OUR REF: 18005

ADDITIONAL INFORMATION AND RESPONSE TO SUBMISSIONS NOS. 19-27 CROSS STREET, DOUBLE BAY (DA 321/2020)

Thank you for the opportunity to provide amended plans and additional material for the Development Application (DA 321/2020) for the proposed demolition of the existing building and construction of a shop-top housing development at Nos. 19-27 Cross Street, Double Bay.

Figure 1: Section Showing Original and Proposed Envelope

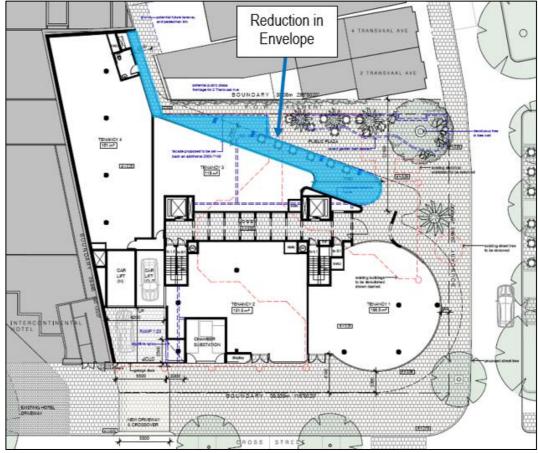
- Overall reduction in GFA of 136m² (from 4,796m² to 4,660m²), and FSR reduced from 3.59:1 to 3.49:1;
- Reduction in building height by maximum 2.00m (from RL 26.75 AHD at lift overrun and RL 25.59 AHD at the highest point of the roof, to maximum RL 24.75 AHD, noting lift overrun now contained within roof) (see Figure 1 on the following page), and maximum height reduced from 23.5m to 21.5m;

The overall reduction in building envelope from the originally submitted DA, in comparison with the amended proposal, is shown in **Figure 1** on the following page.
